Addendum #1

Lewiston Readiness Center Roof Replacement Project
Project No. 23SR10-461-D, Bid Number #16-040

Directorate of Facilities Engineering

5 April 2016

SHEET ID: S-000 SHEET: 20 of 36

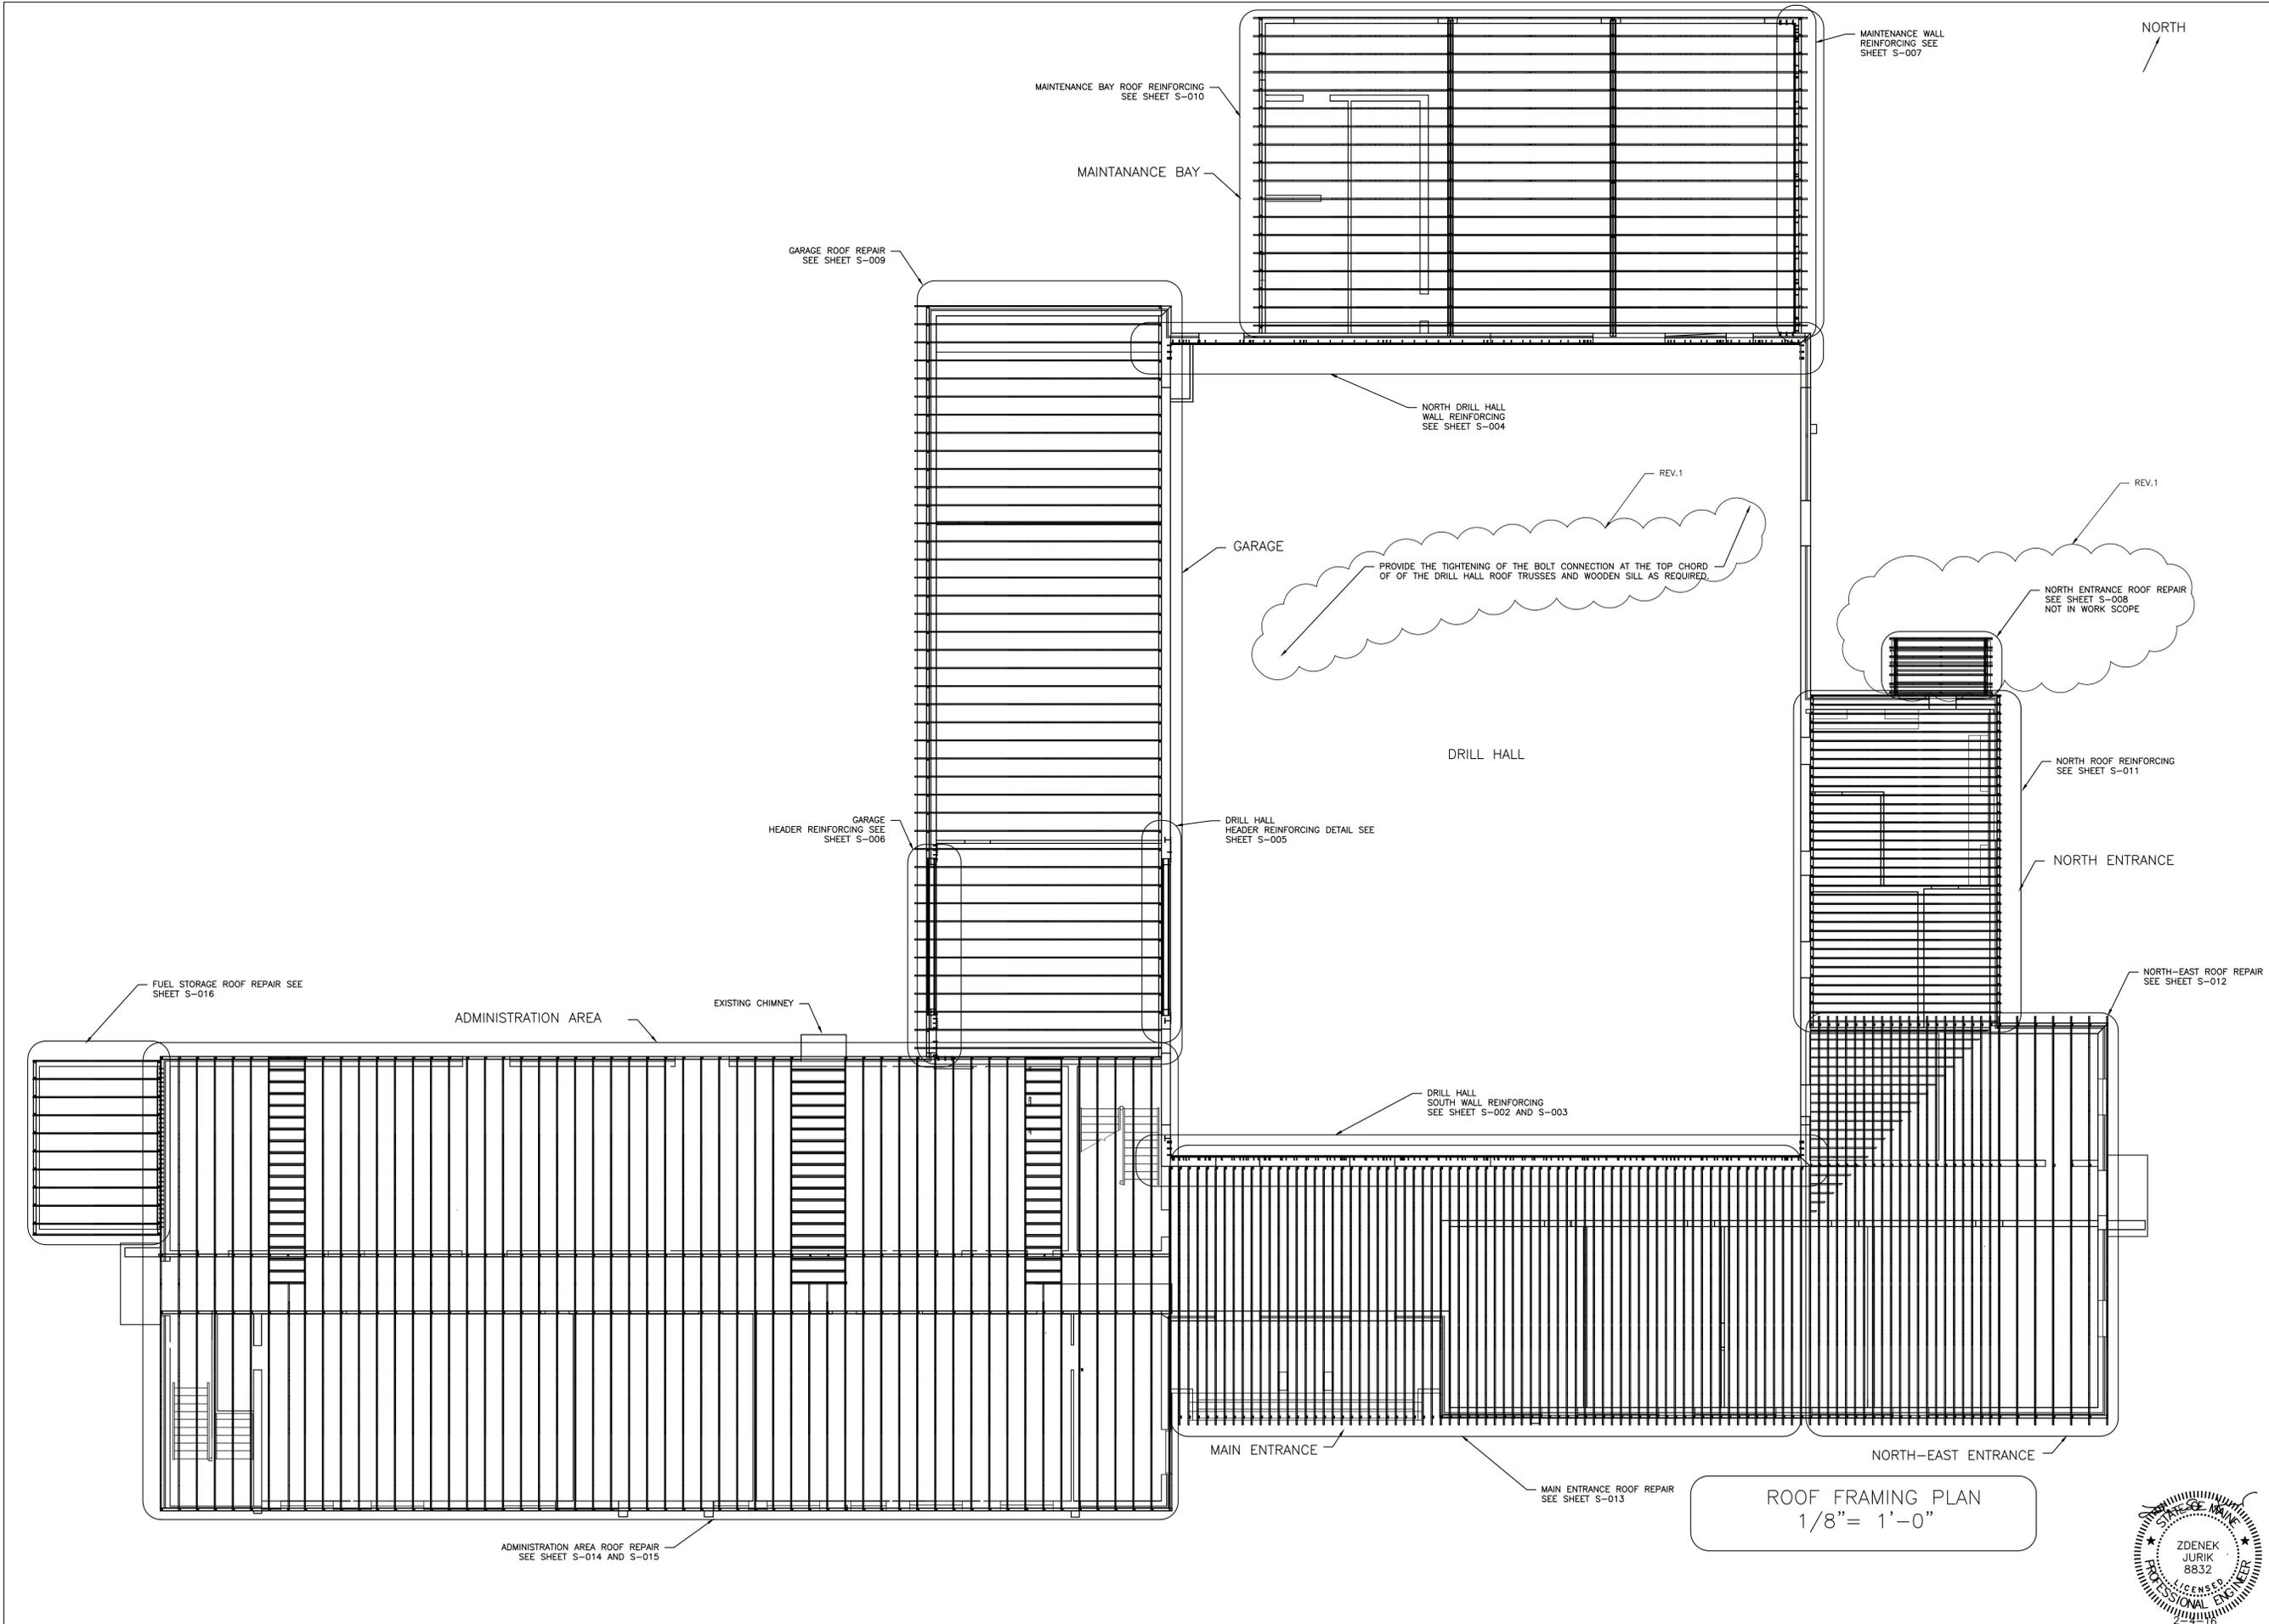
- (14) Sheet S-000: Changed the fastener into tectum decking.
- (15) Sheet S-001: Added the tightening of drill hall truss top chord bolts.
- (16) Sheet S-004: Modified the steel reinforcements of the north drill hall wall for a future door opening.

SHEET ID:
S-004
SHEET: 24 of 36

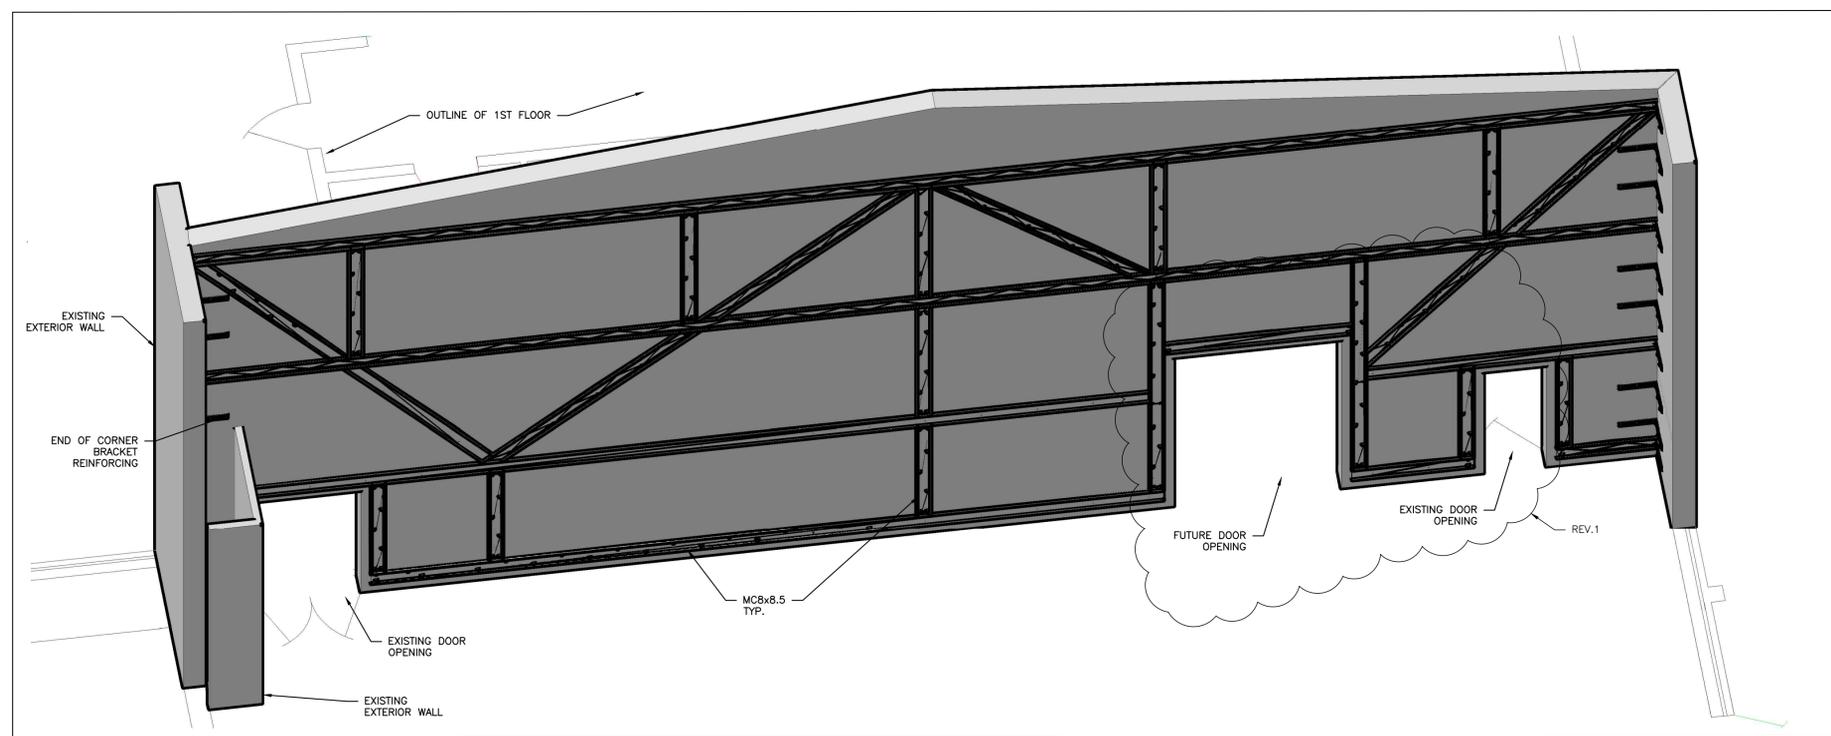
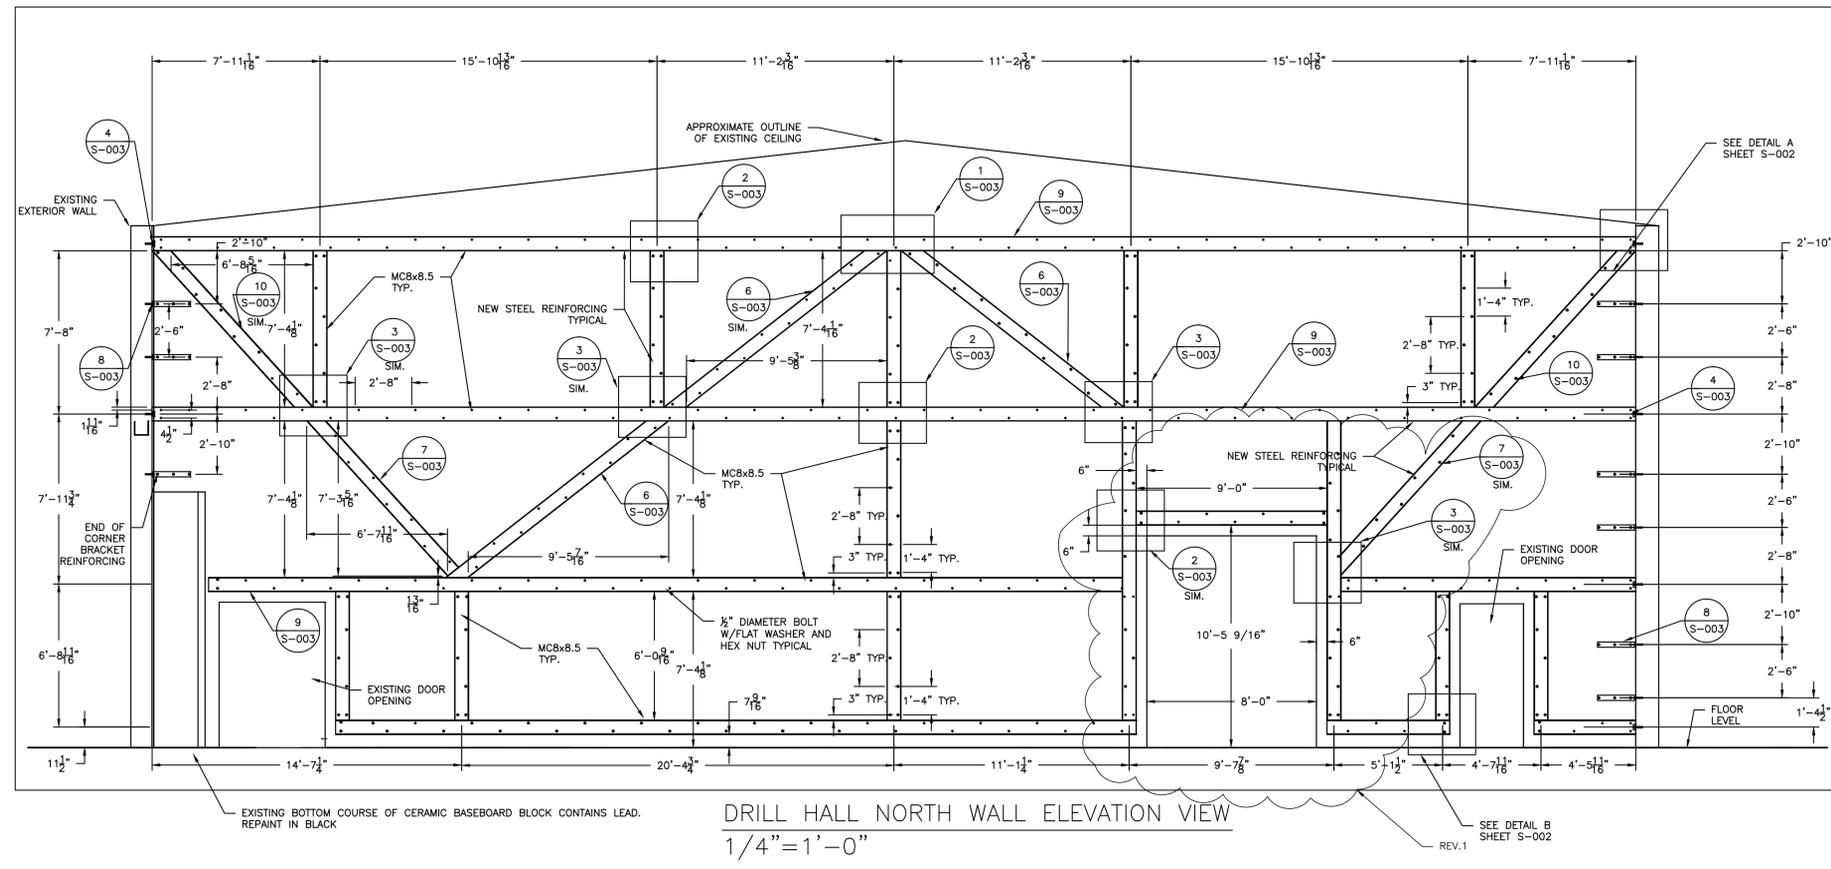
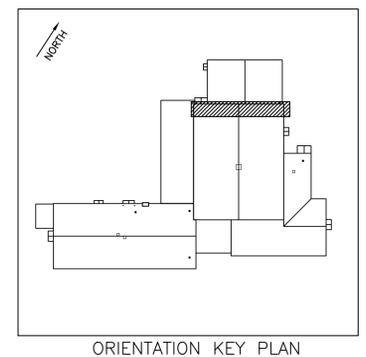
PLAN REVISIONS	
Rev#	Description
1	NEW OPNG. REINFORCING CHANGE DRW TO BID SET 3-31-16

SHEET ID:
 S-008
 SHEET: 28 of 36

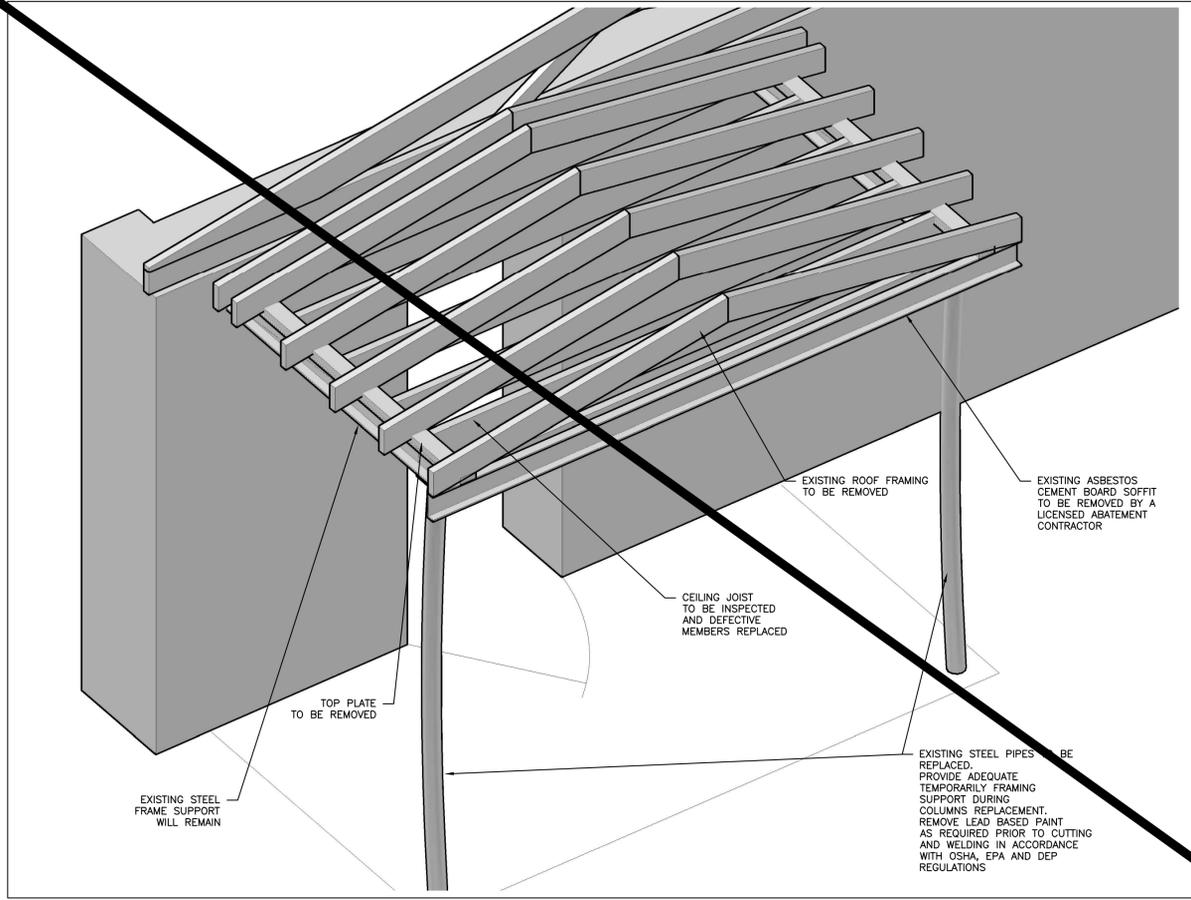
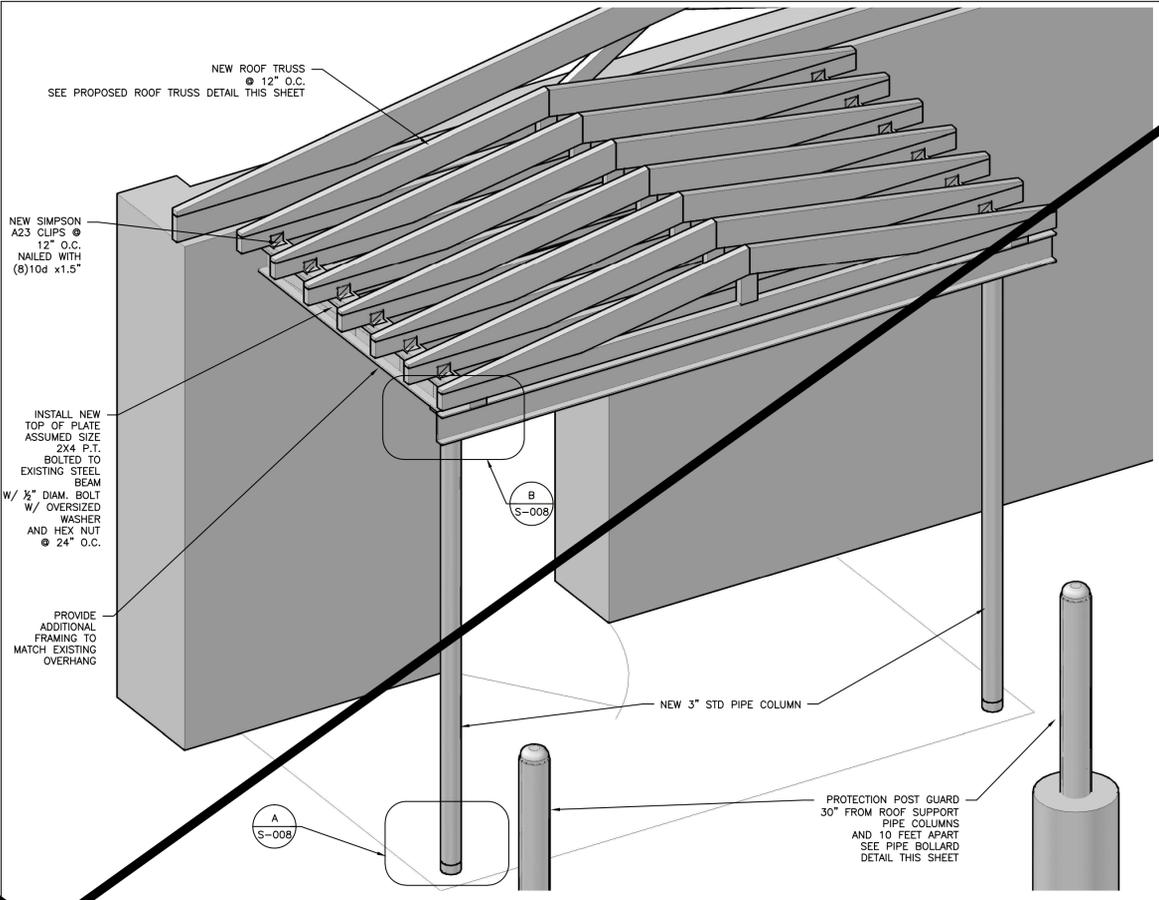
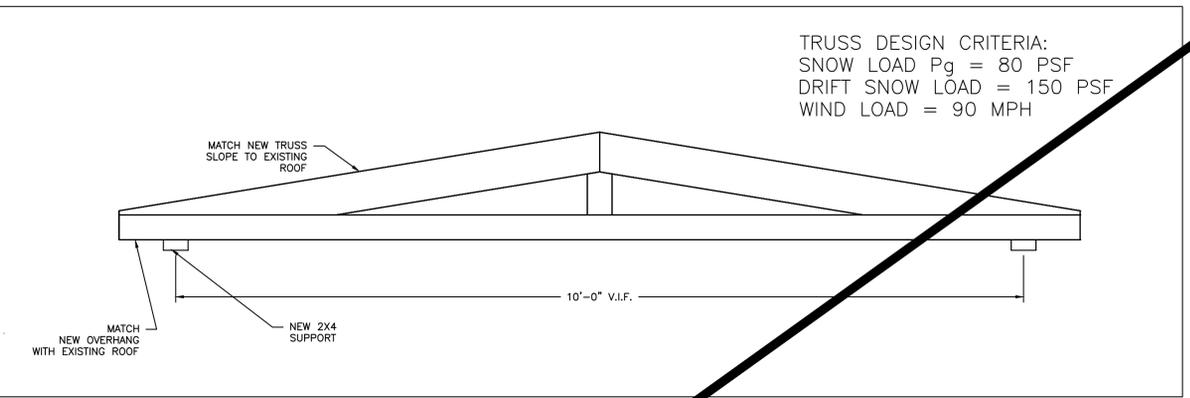
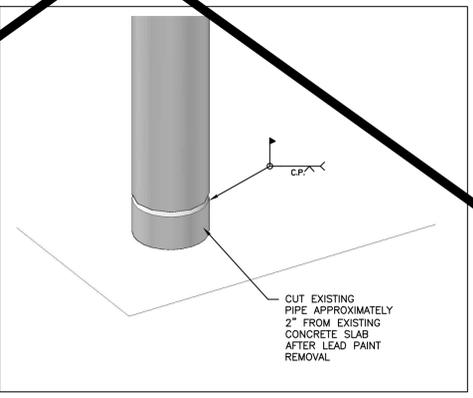
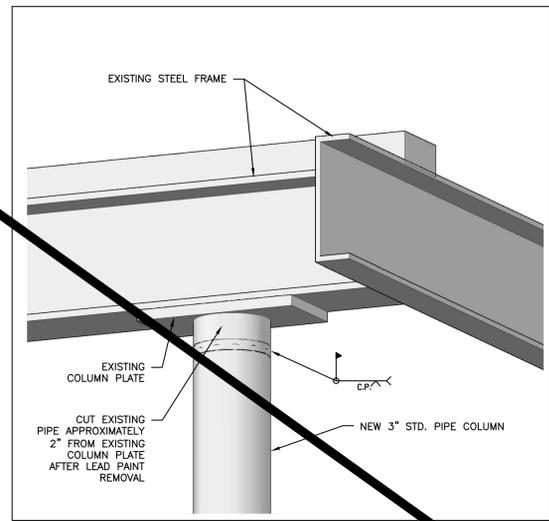
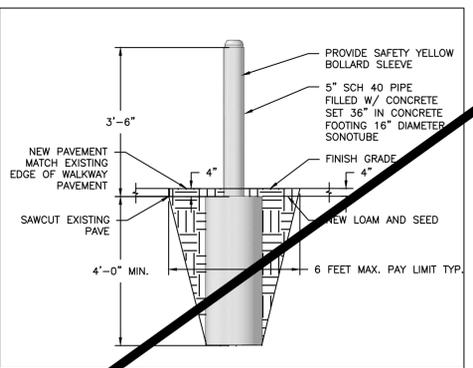
- (17) Sheet S-008: Eliminated from the scope of work.

NOT IN SCOPE
